Submission - SSD – 85869467 Concept and Stage 1 – ANZAC Village Seniors Housing

The following comments are provided for consideration and to assist the Department in the assessment and determination of the **SSD – 85869467 Concept and Stage 1 – ANZAC Village Seniors Housing**

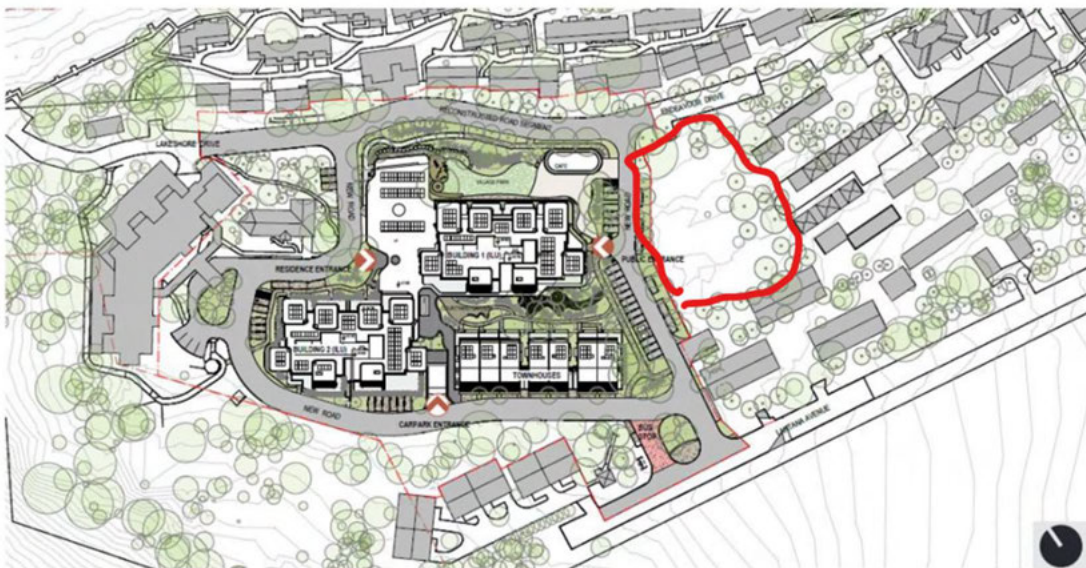
The EIS highlights the community engagement and stakeholder consultation that has occurred – which also neglected to identify the Stage 1A works included in this DA. Section 1.4.2 Stage 1 works does not reference the Stage 1A component of the DA. The EIS includes a map (below) which does not reflect the Stage 1A component of the DA which will occur in the area marked as Stage 2.

Figure 35 Overview of proposed Stage 1 demolition across the site

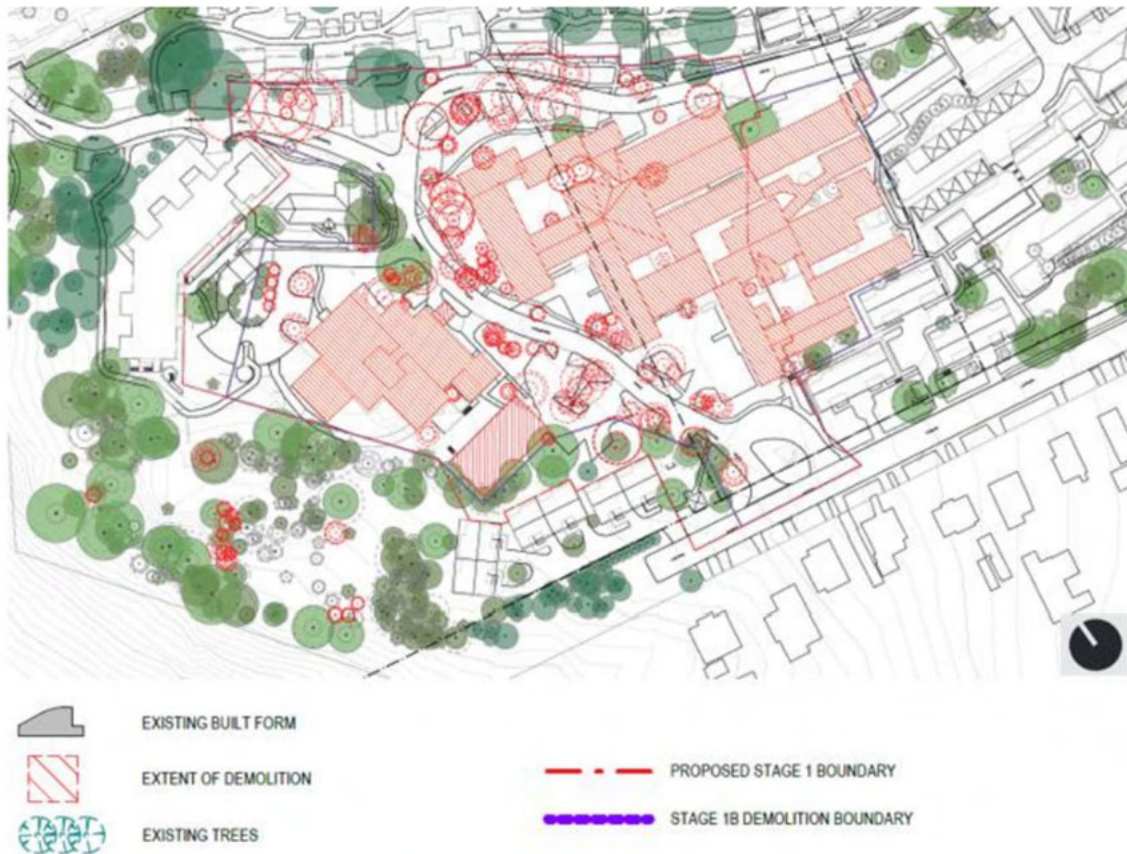
Section 3.5 Stage 1 Detailed Works – 3.5.1 Demolition and Site Preparation Works – 3.5.1.1 page 65 (and Figure 35 and 36 copied below) is the first indication in the EIS that the Stage 1 works will directly impact the land identified as Stage 2 and Stage 5 noting that the Detailed consent for demolition is also sought for:

In addition to the fact that this detail seems to be hidden in the document and has not been openly communicated – the use of the area identified as Stage 1A (see map below) as a temporary construction staging and storage area for Stage 1 is another significant

reason why the existing residents in the Stage 2 have been misled to believe the Stage 1 works will not impact them. As mentioned above construction staging, storage areas, and side sheds are established prior to construction, and remain for the duration of a project. They can't be called stage 1a in small print under stage 2.

I have been unable to find any reference to the temporary use of the Stage 1A area for staging and storage or the roadworks associated with Lantana Avenue and entry point in any of the appendices, therefore I believe the future use and works (whatever they maybe) have not been considered in the EIS. This should be rectified / re exhibited before any determination of this proposal.
